**ADDENDUM NUMBER ONE
to the
PROJECT SPECIFICATIONS
and
CONTRACT DOCUMENTS
for
Park Avenue Improvements Project
Project # 14-2157810-8930-09648**

DATE OF ADDENDUM: April 4, 2014

PARK AVENUE IMPROVEMENT PLANS
 PLAN SHEET ADDENDUM
 ADDENDUM C19

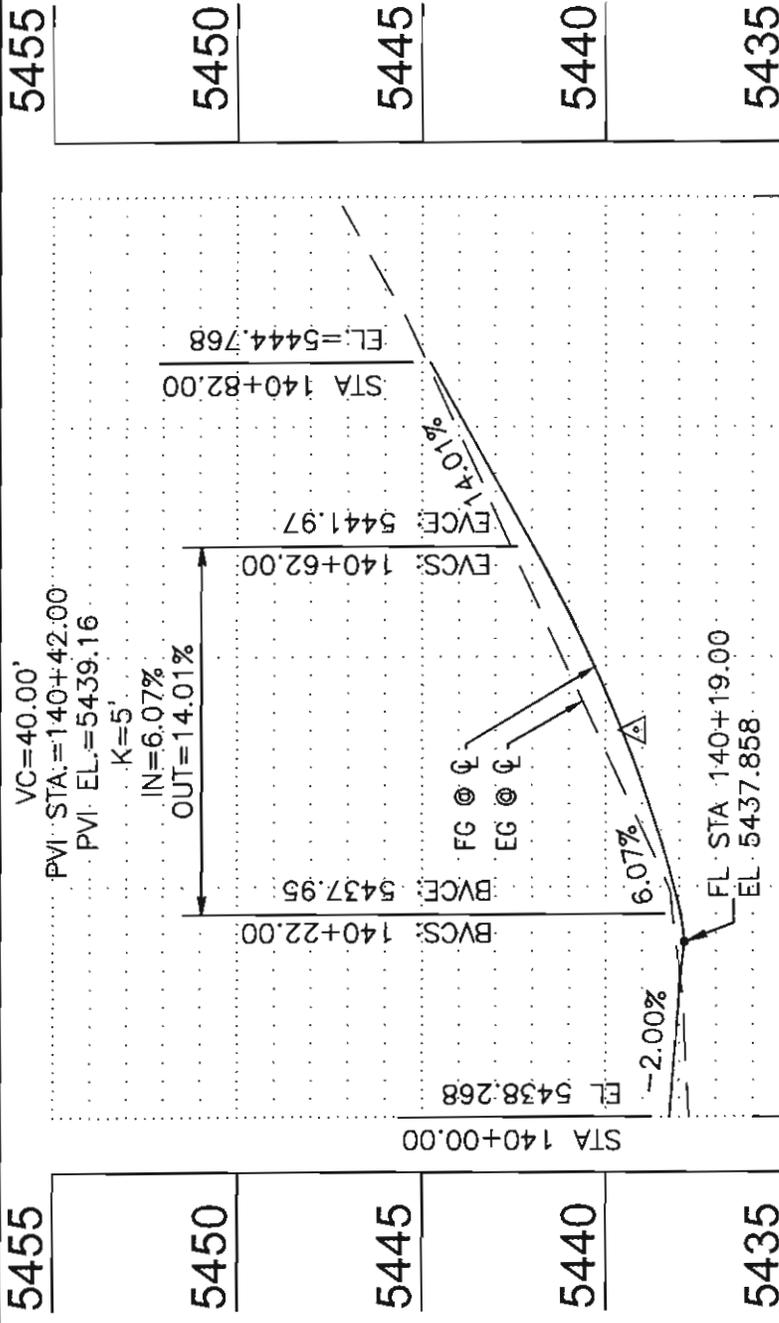
1. DELETE Transition Area 2" Mill and Overlay.
2. ADD 1.5" Transition Area Mill and Overlay.
3. Curb Transition Detail: 221-2, Drawing D2, Sheet 95 without riprap, Sta. 140+94.00 LT.
4. ADD Paving Construction Note No. 3 as follows:
 3. 1.5" overlay shall be monolithic with the top lift of the reconstruction area top lift of AC Pavement.
5. See attached drawing for W Glendale vertical alignment information.

PARK AVENUE IMPROVEMENT PLANS
PLAN SHEET ADDENDUM
ADDENDUM W5

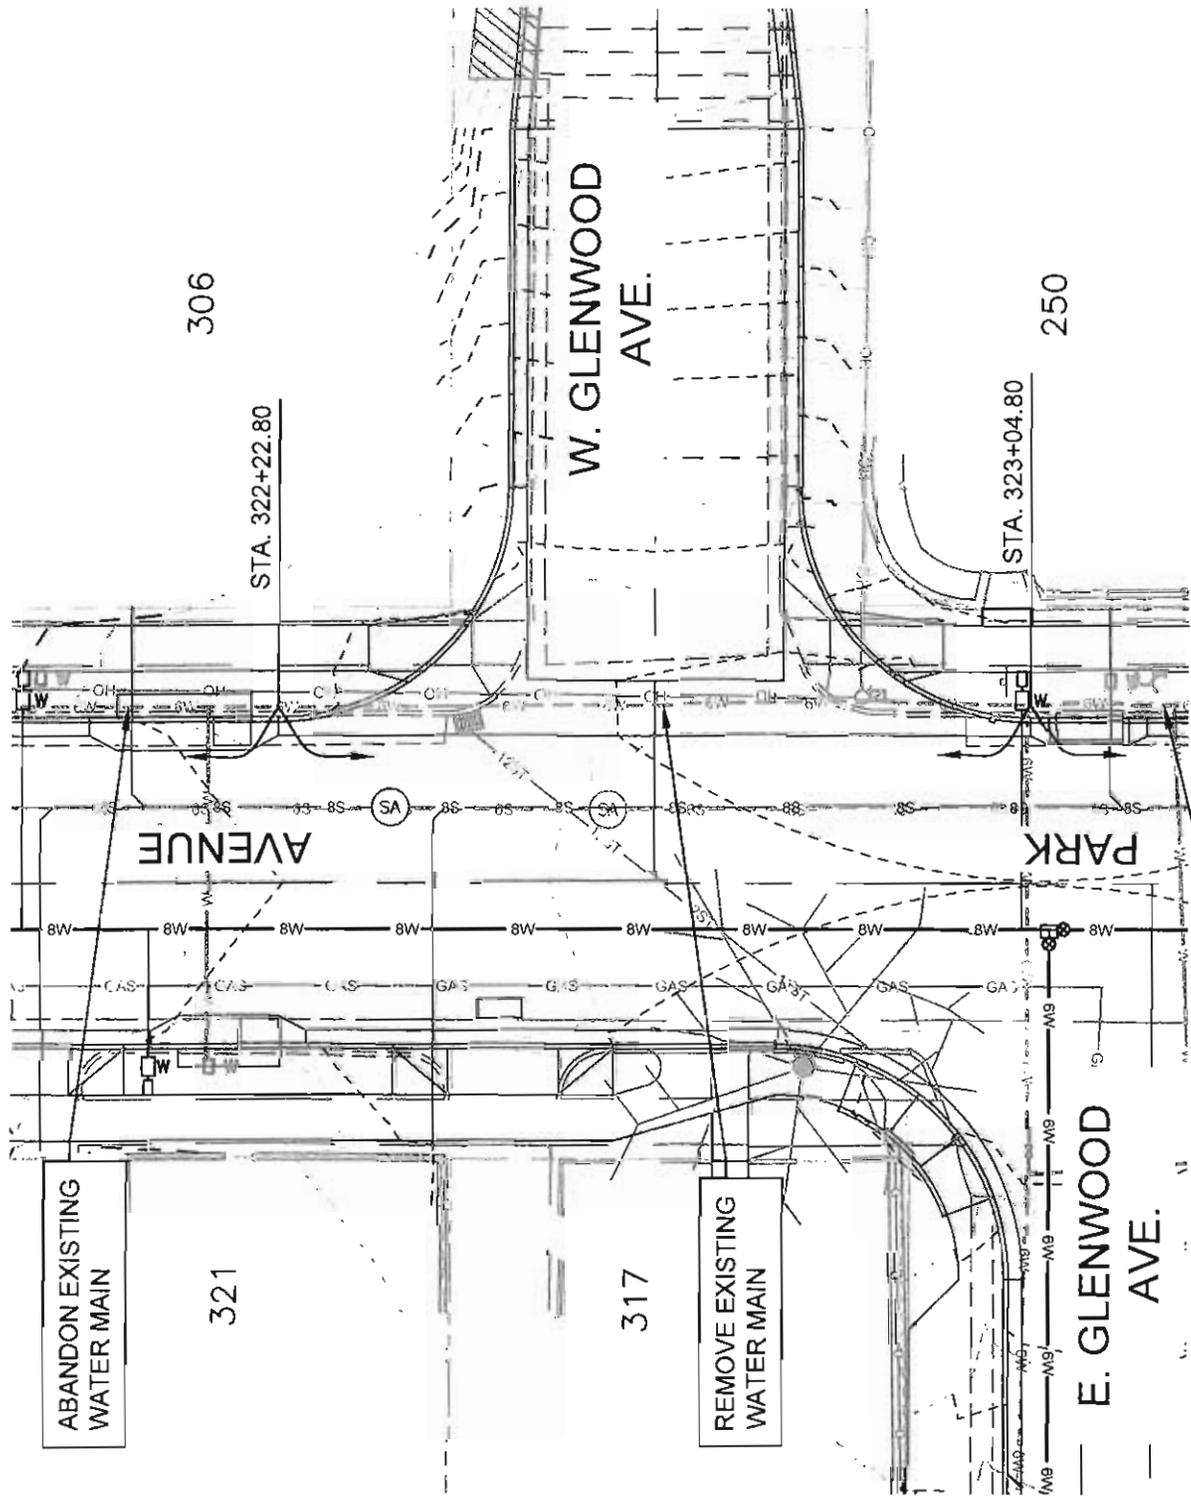
ABANDON EXISTING
WATER MAIN

REMOVE EXISTING
WATER MAIN

ABANDON EXISTING
WATER MAIN

PARK AVENUE IMPROVEMENT PLANS
PLAN SHEET ADDENDUM
ADDENDUM W11

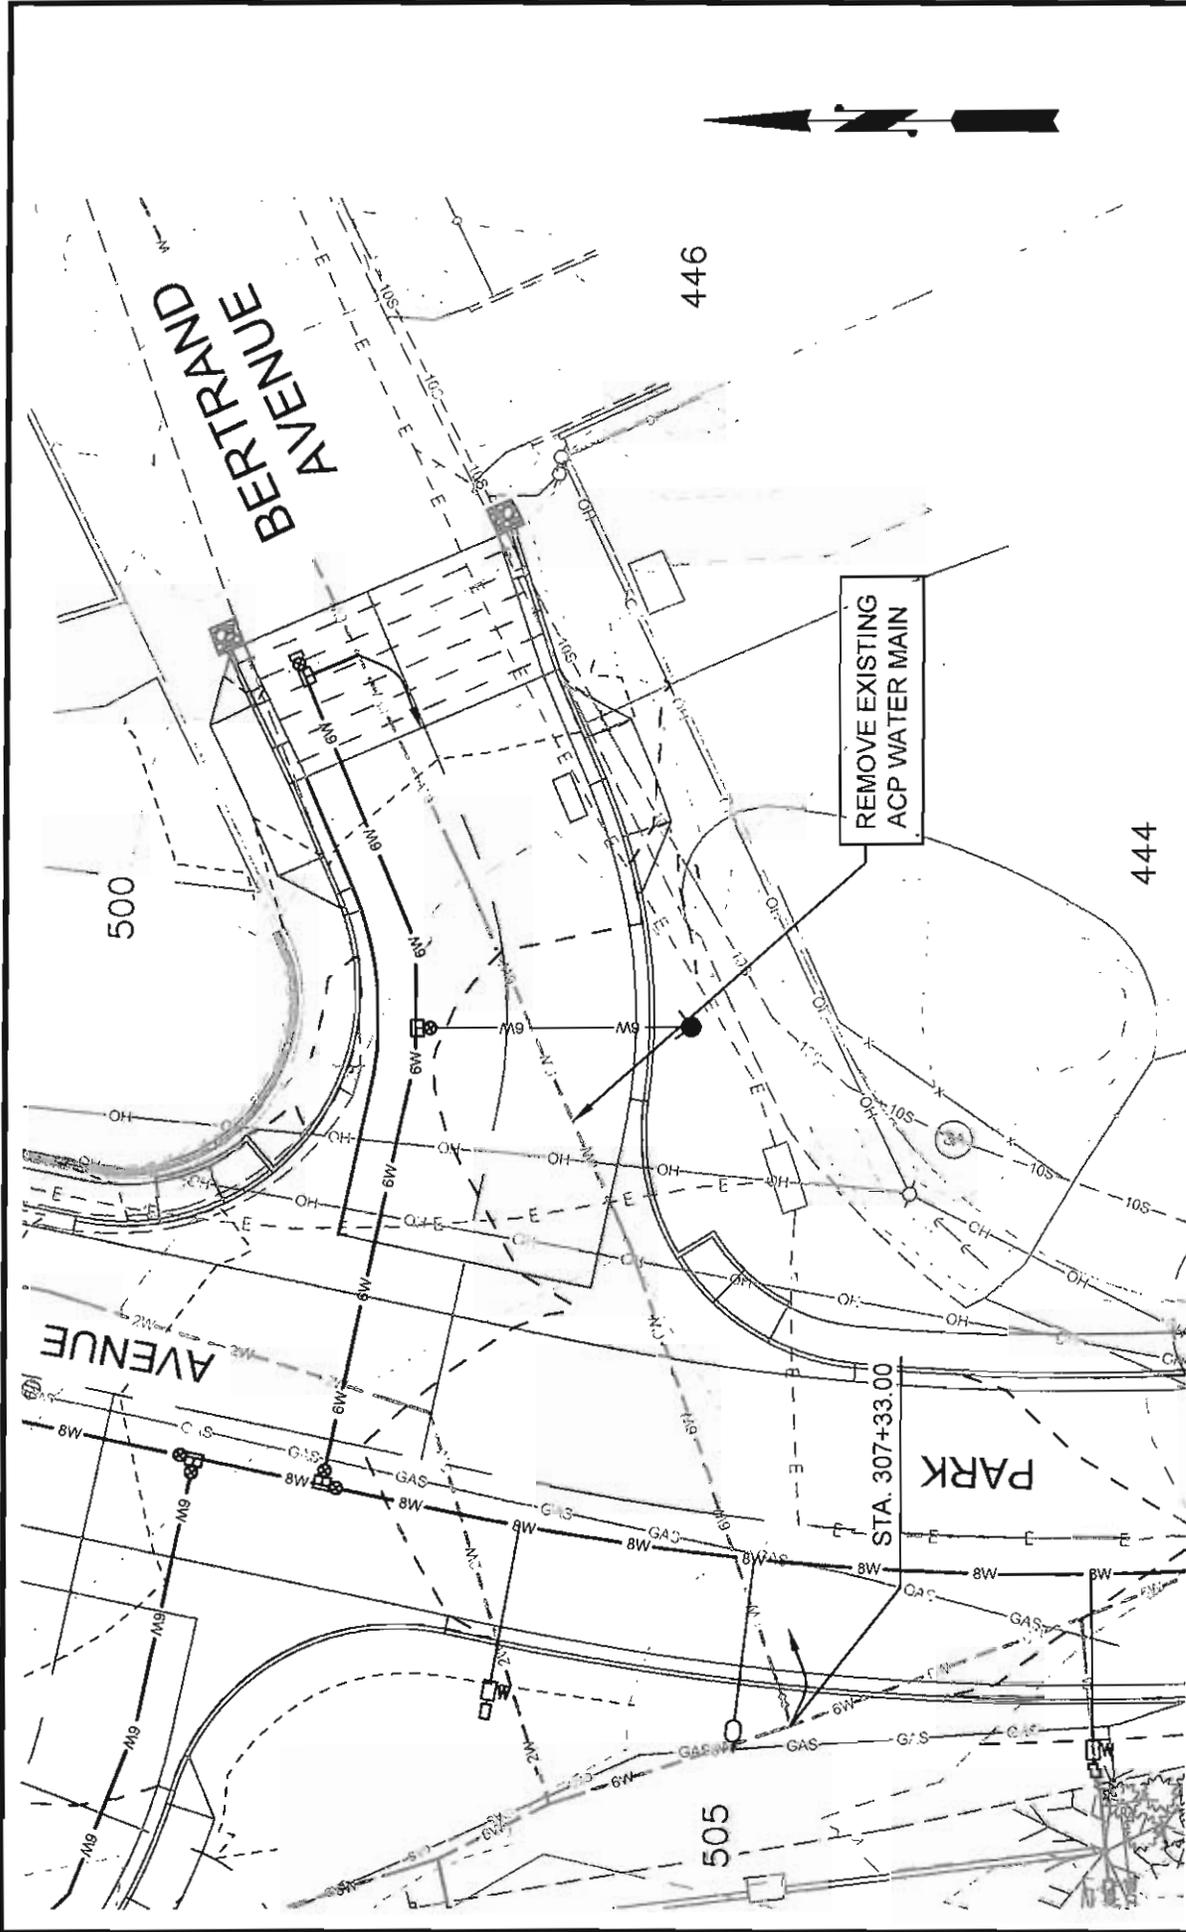
Sheet W11, Drawing 55

1. The connection to the existing water main shall be in accordance with COP Standard Detail 380A-P (modified).

**PARK AVENUE IMPROVEMENT PLANS
 PLAN SHEET ADDENDUM
 ADDENDUM W12**

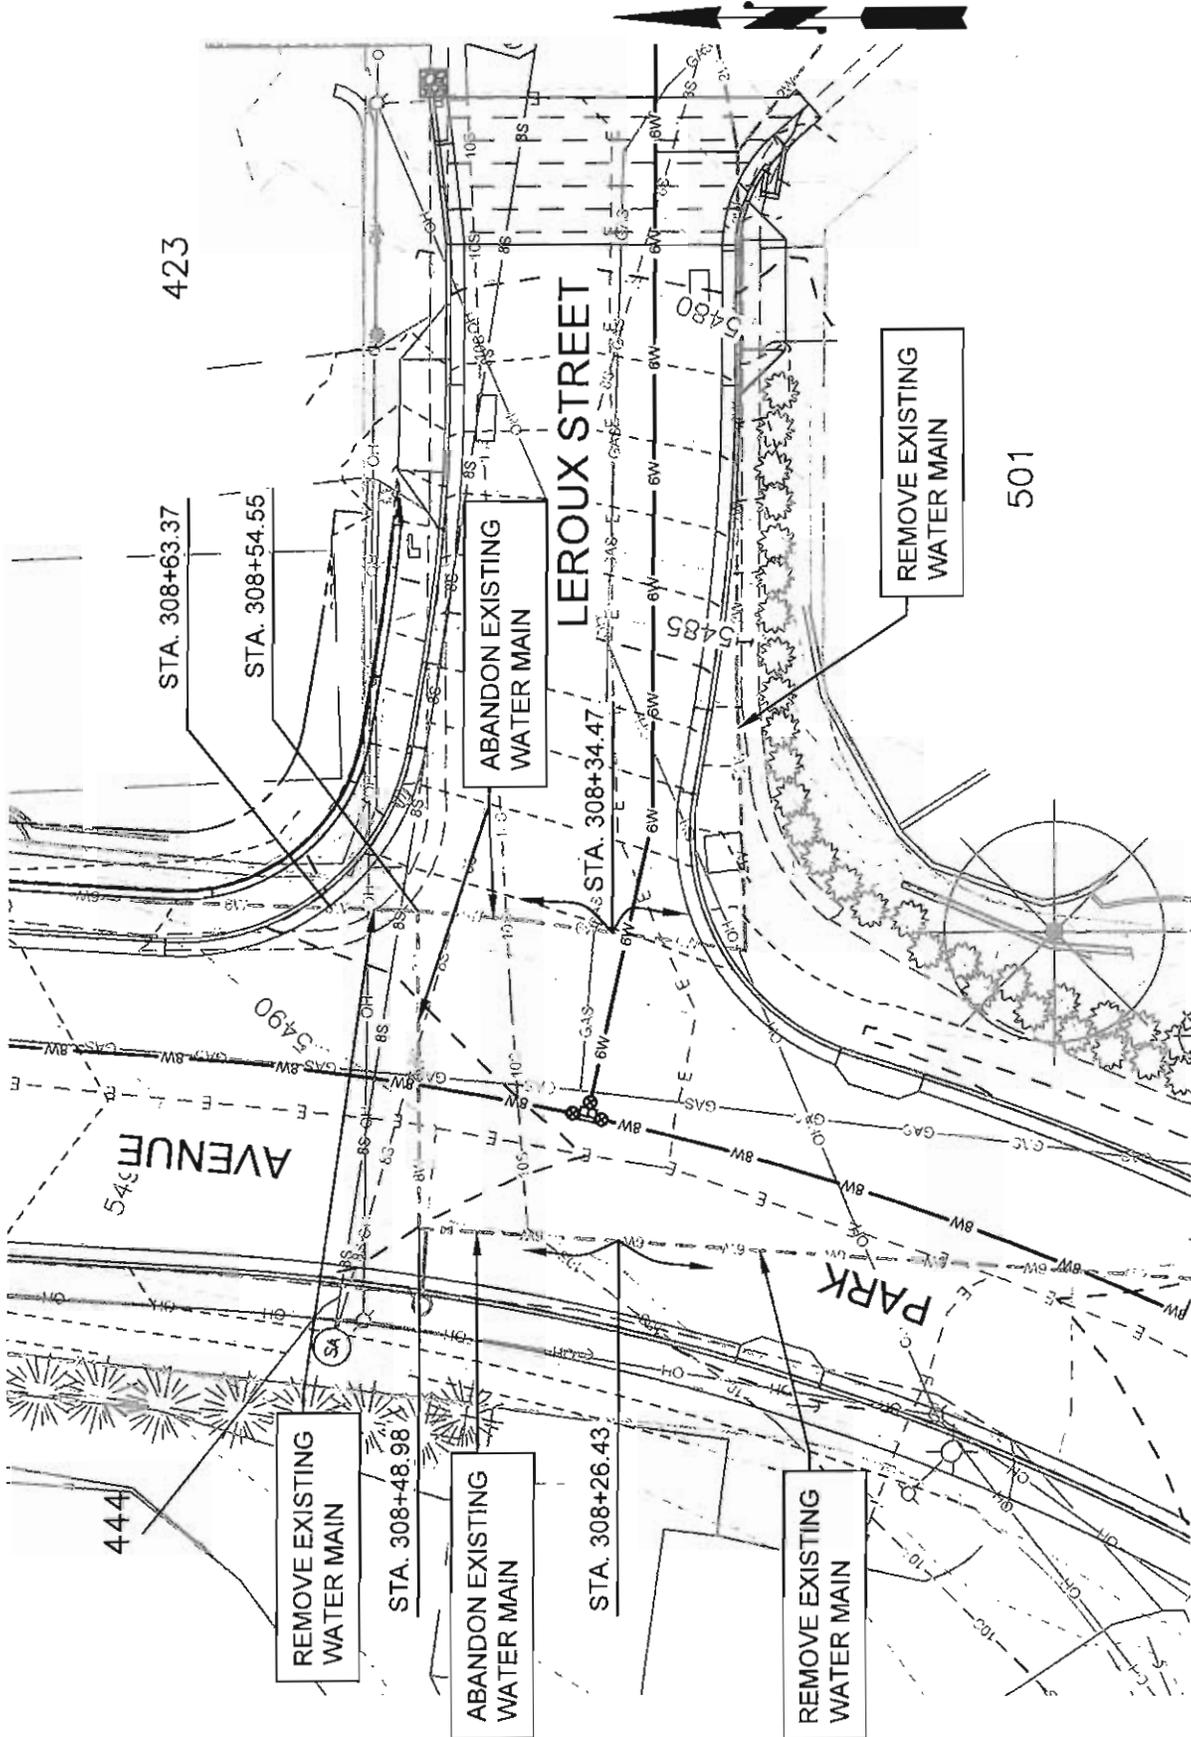
1. All existing water mains shall be removed in accordance with Specification Section 350 unless otherwise noted on Addendum No. 1 drawings.

PARK AVENUE IMPROVEMENT PLANS
 PLAN SHEET ADDENDUM
 ADDENDUM SA17

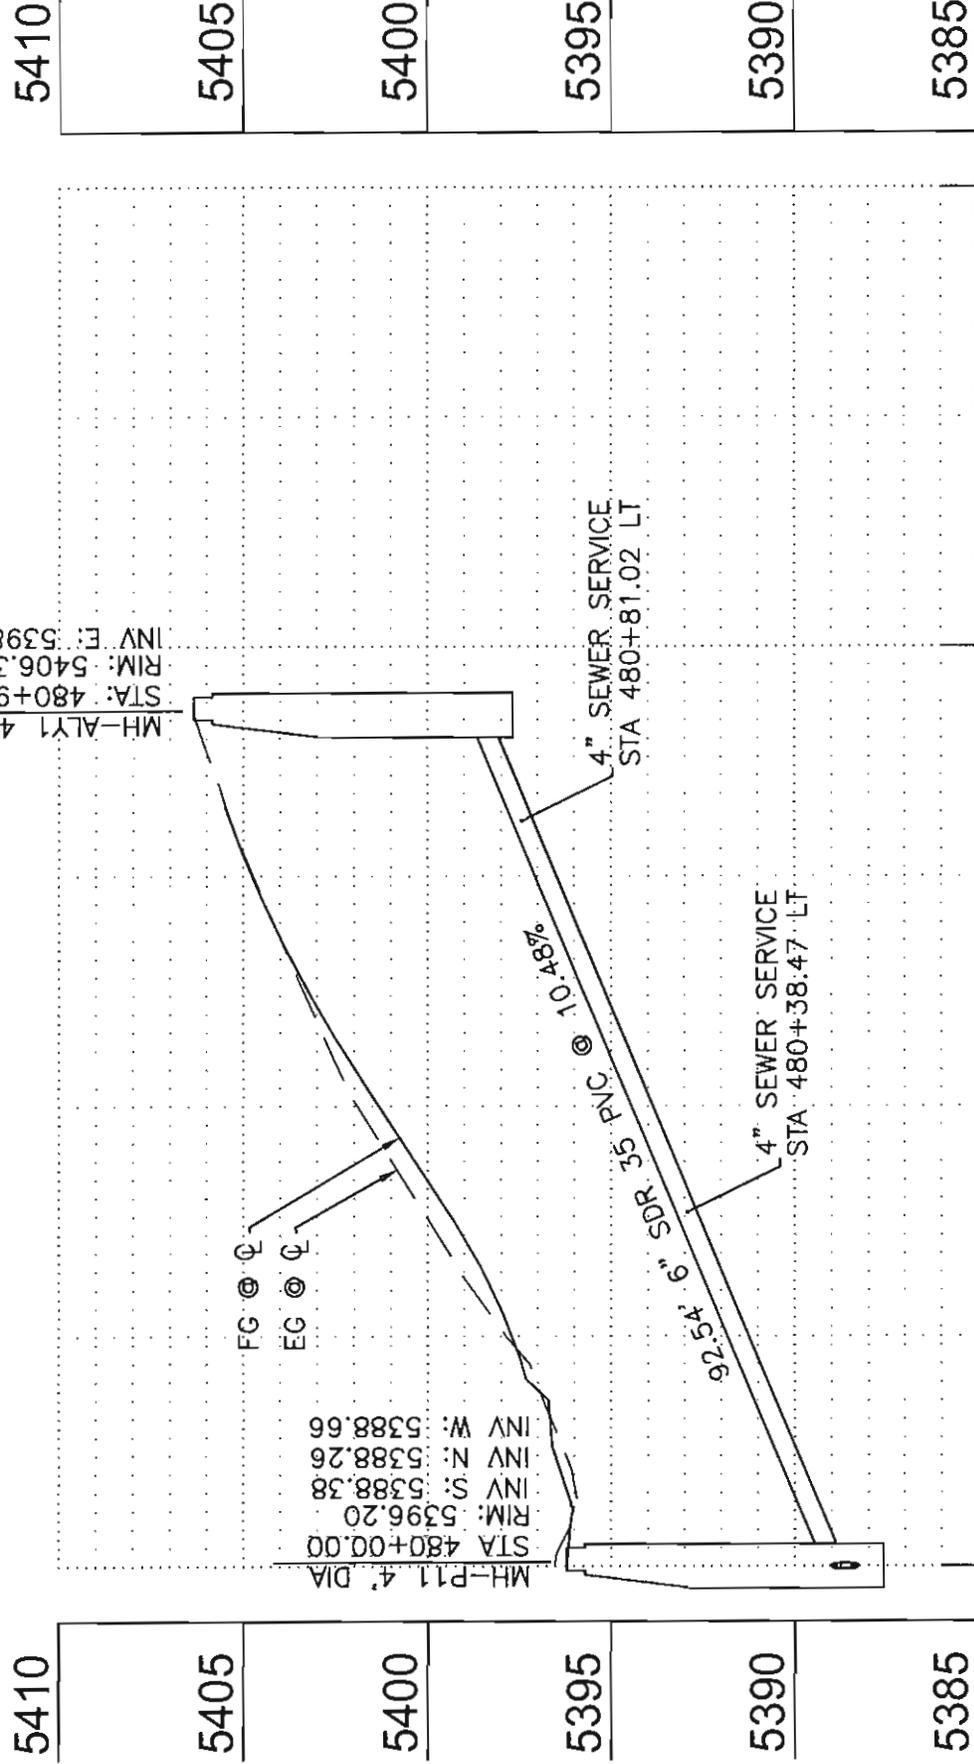
1. CHANGE proposed 6' SDR 35 PVC to 8" SDR 35 PVC.

DETAIL NO.
DW-E

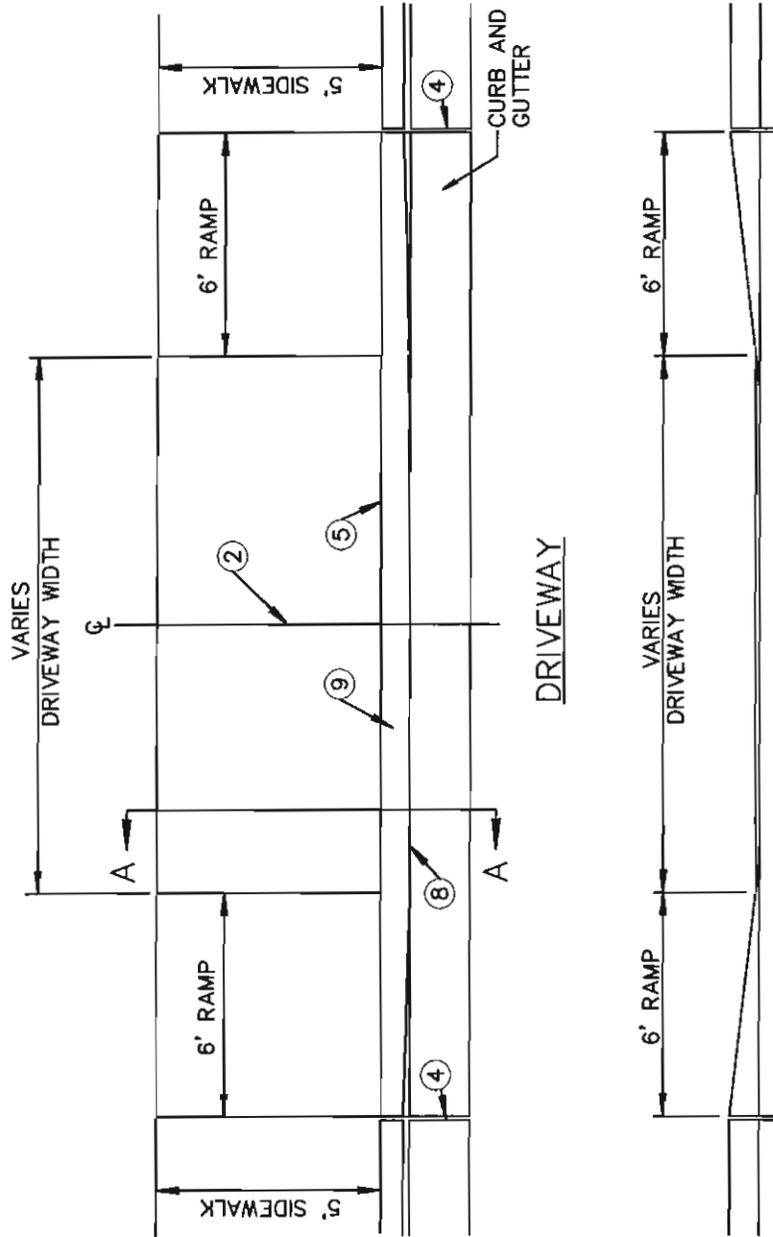
1. All concrete on Detail DW-C shall be 6-inches thick.
2. All concrete on Detail DW-D shall be 6-inches thick.
3. DW51 at Sta. 130+86.89, LT (Country Club) shall be constructed in accordance with Detail DW-E, attached.
4. DW53 at Sta. 150+44.06, RT (Glendale) shall be constructed in accordance with Detail DW-D on the same sheet.
5. DW55 at Sta. 57+67.39, RT (Park) shall be constructed in accordance with Detail DW-D on the same sheet.
6. DELETE the annotation "DW54 DRIVEWAY WITH DETACHED SIDEWALK" from Detail DW-D.
